SUBJECT: Transmittal of Responses to AP1000 DSER Open Items

Draft Safety Evaluation Report Open Item Response

DSER Open Item Number: 4.5.1-1 Response Revision 1

Figure A-1: AP1000 Containment Backpressure Sensitivity

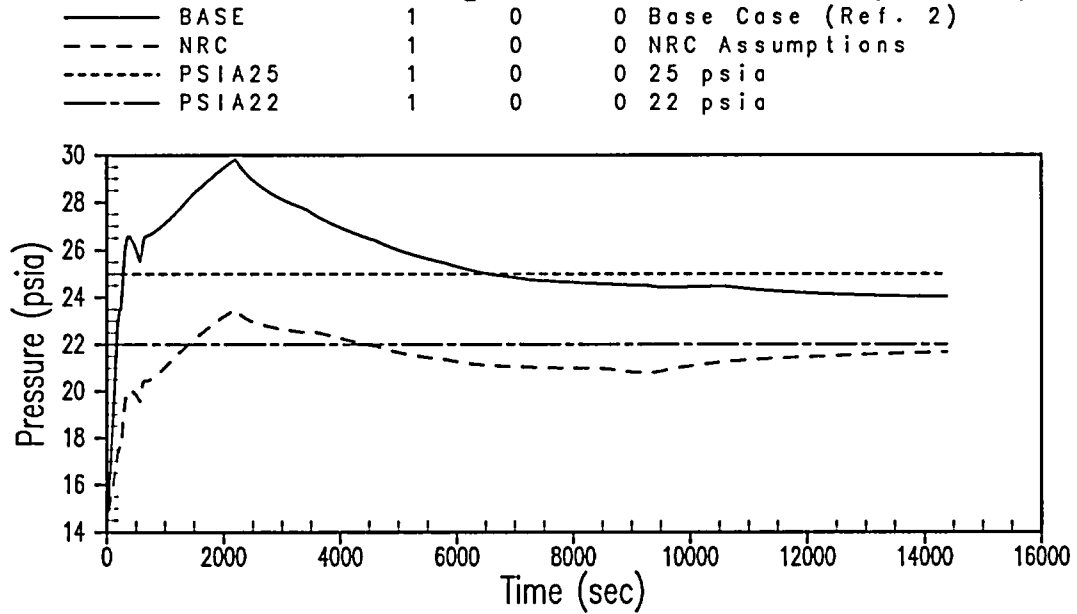
4. It is the staff's recommendation that the WGOTHIC small-break LOCA and long-term cooling model be modified to include the most conservative assumptions from the WGOTHIC minimum pressure for large-break LOCA model. Specifically,

- c. The remaining head structure areas should be increased by a factor of 2.1 or a lower value if justified based on an accounting of expected structures in the final as-build plant.

The NRC recommendations listed above were incorporated into the WGOTHIC small-break LOCA and long-term cooling model, and the pressure response to a double-ended DVI break LOCA is shown in Figure A-1 as the NRC case. Also shown as the base case is the pressure using the assumptions from the approved methodology in Reference 2.

The following are Westinghouse comments regarding the recommendations of the staff assessment and discussion of the parameters used in the WGOTHIC analyses for Figure A-1:

Figure-1 DEDVI 22.0 PSI – Vessel Side Liquid Break Discharge

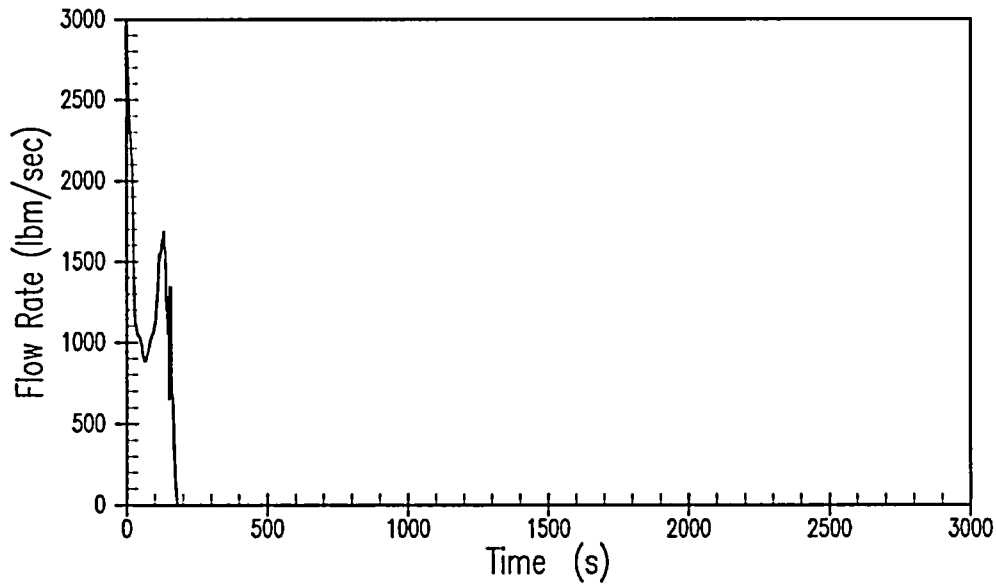
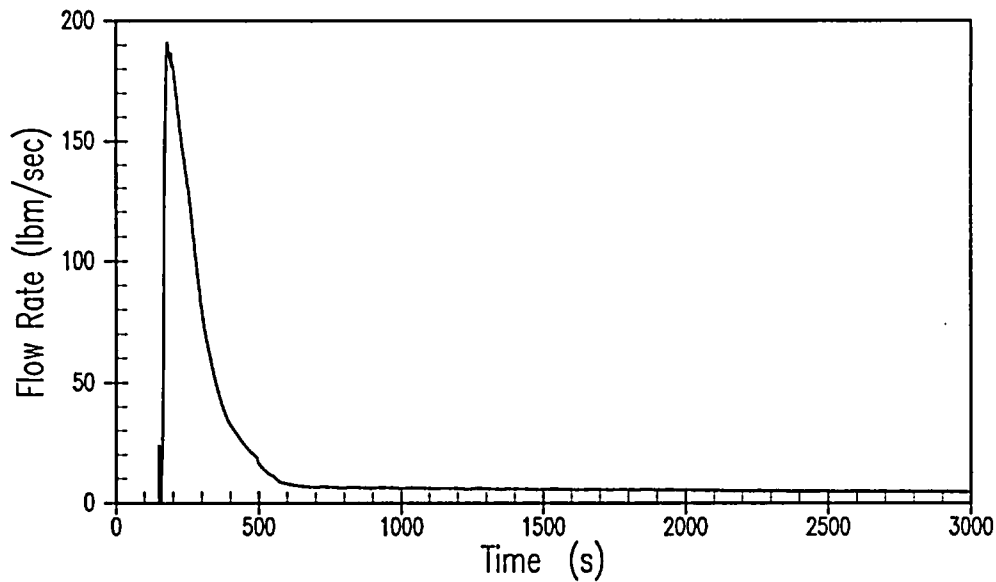
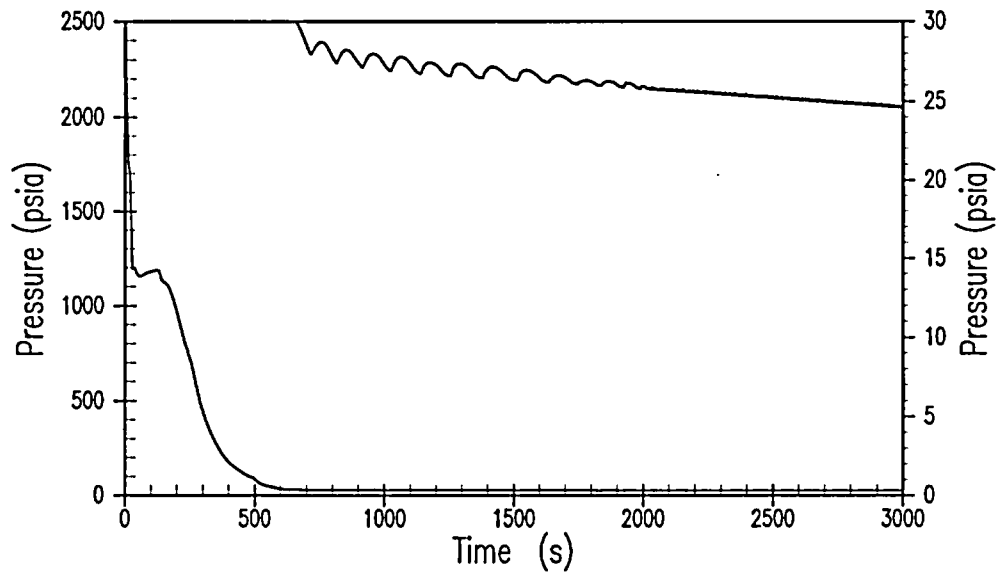
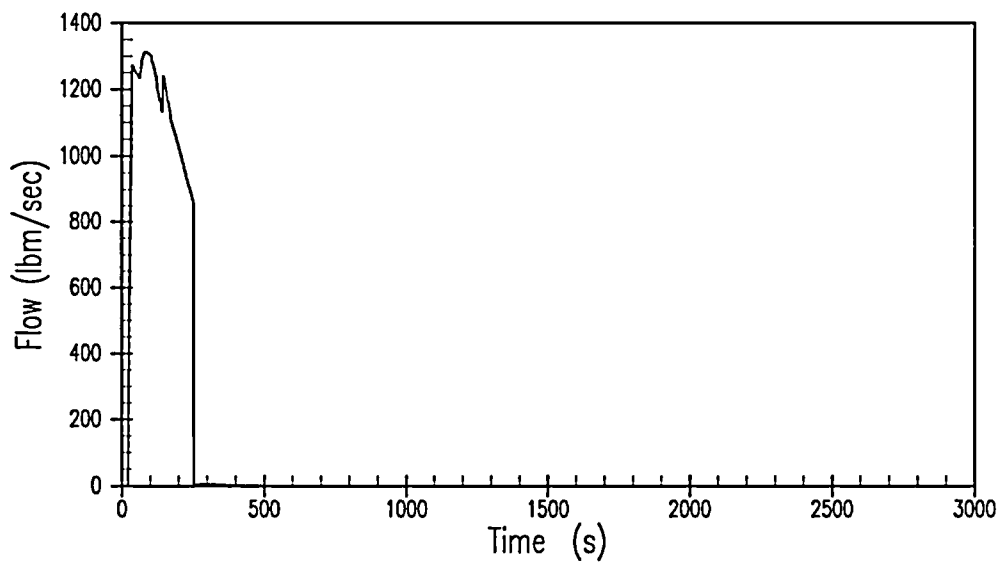
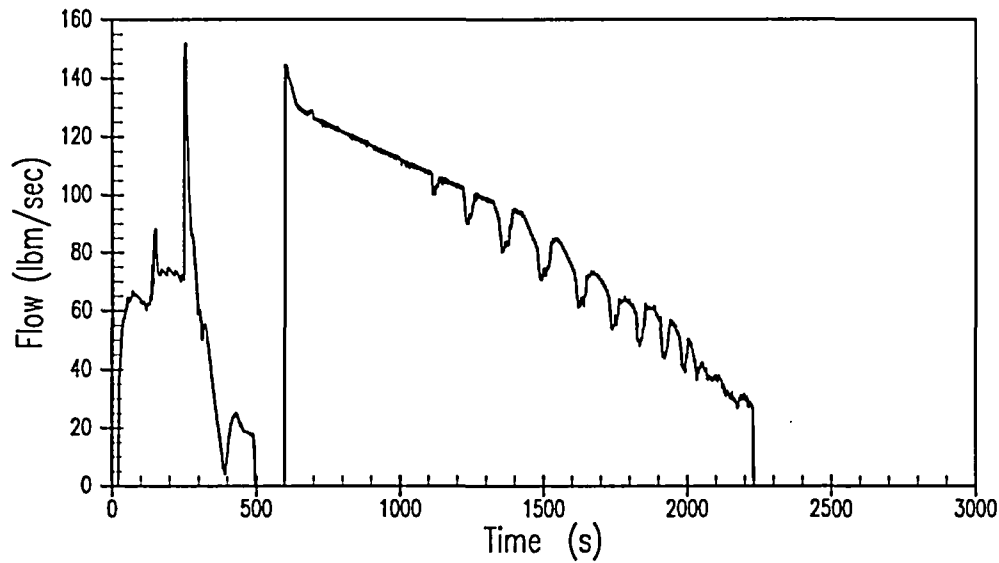
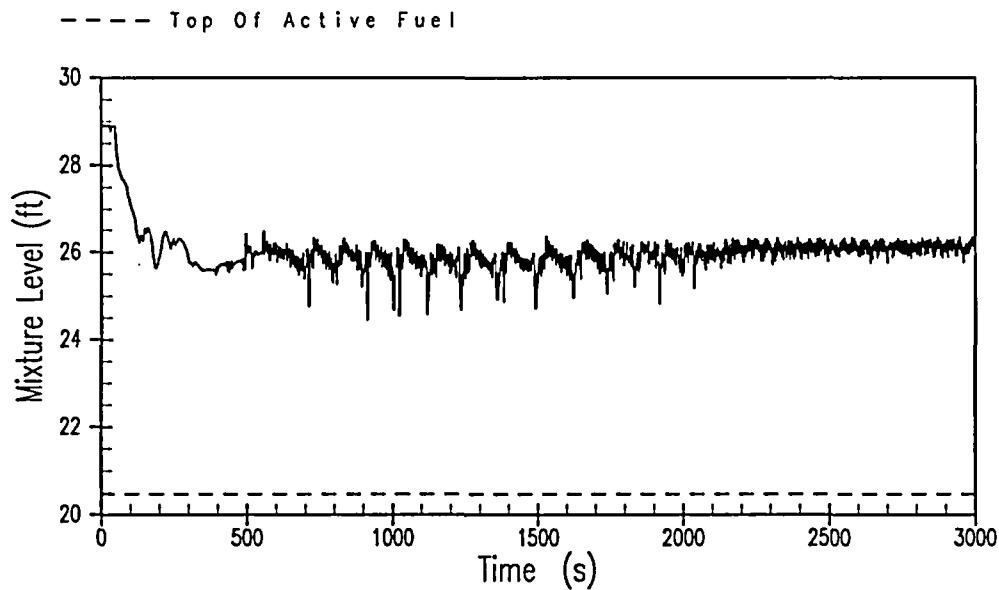
- a) Provide complete graphs of minimum containment pressure, minimum containment water level and minimum water temperature as a function of time for 30 days.

The staff calculations show that the ability to cool the core is highly dependant on containment pressure, containment water level, and sump temperature. Westinghouse has provided us with containment pressure only for the first 10000 seconds and then at 14 days and 28.5 days, and the containment water level only at 2.6 hours, 14 days and 28.5 days.

- c) A NOTRUMP analysis for the DEDVI case using 22 psia containment pressure has been performed, consistent with the WGOETHIC case in Attachment A with NRC assumptions. Table 1 and Figures 1 to 20 provide the results of this NOTRUMP analysis. The AP1000 DCD will be revised to replace the existing DEDVI 25 psia case with the DEDVI 22 psia case shown here. In AP1000 DCD Revision 3 a NOTRUMP case was presented with a containment pressure of 14.7 psia. This analysis is still a valid analysis for the AP1000 and the AP1000 DCD will be revised to re-insert this case.

Figure 1 – AP1000 Decay Heat Values

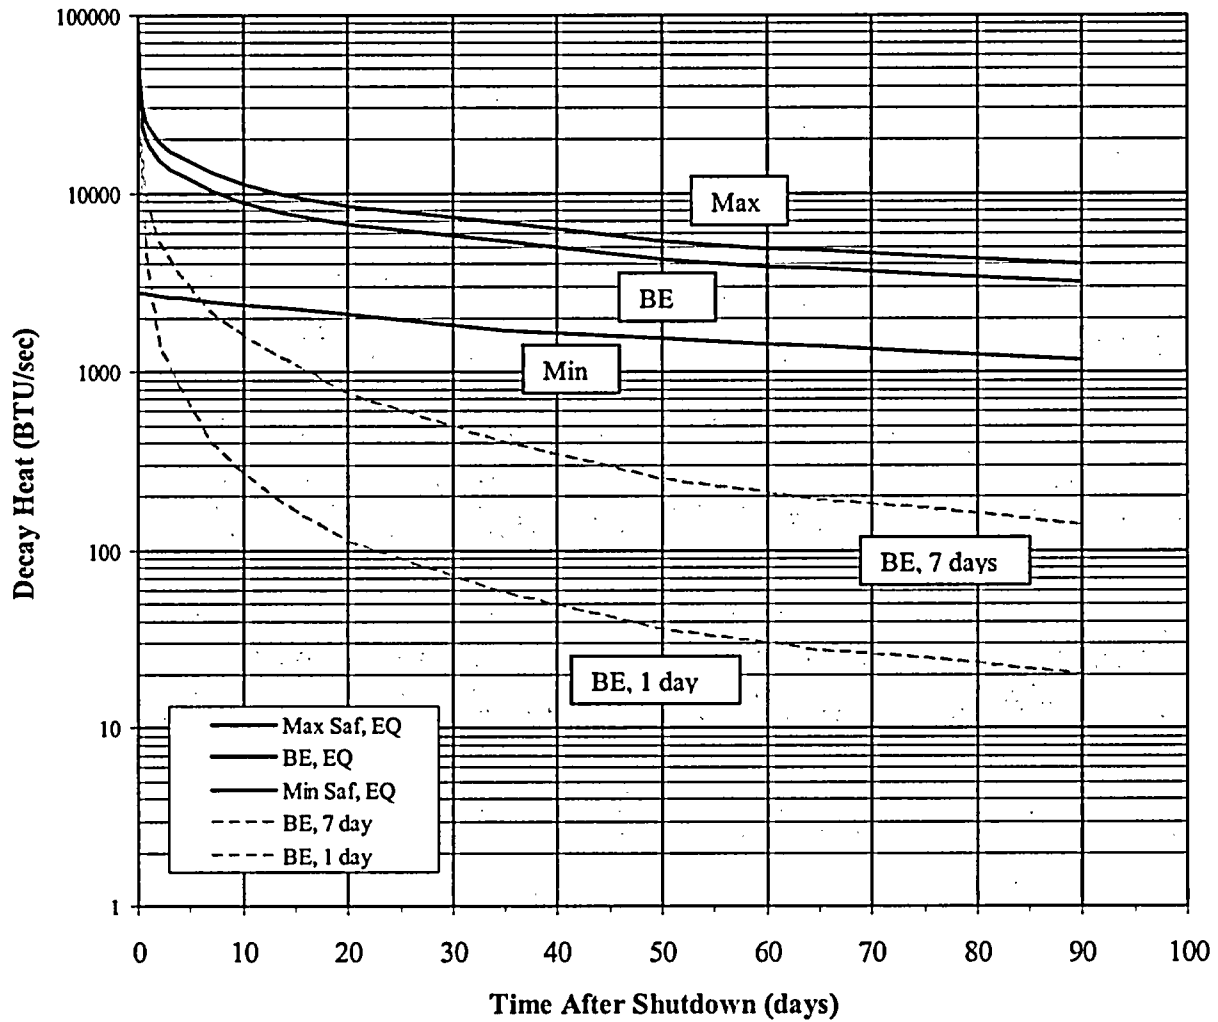
Summary of Remaining Issue: Provide the following information regarding long-term cooling boron precipitation: (1) the longest time for which the LTC is viable in terms of boron precipitation (i.e., identify the point in time entrainment no longer removes liquid through ADS-4 lines); (2) the shortest reactor operating time which results in sufficient decay heat and steam generation to support boron removal by expulsion of liquid from the ADS-4 valves.

- (2) The decay heat from the initial core has been analyzed for short irradiation times. For such a situation, the long-term decay heat decreases more rapidly than for an equilibrium core as shown in Figure 1.

Table 1 (Case 2) and 2 (Case 7) show that the minimum decay heat required with a containment level of 107 ft is 433.2 BTU/sec. From Figure 1, the time when this decay heat would be reached for a first core irradiated for 7 days would be more than 30 days after shutdown. This will provide the operators more than enough time to take actions to maintain and increase the containment water level. Higher water levels provide additional LTC times for a first core irradiated for 7 days.
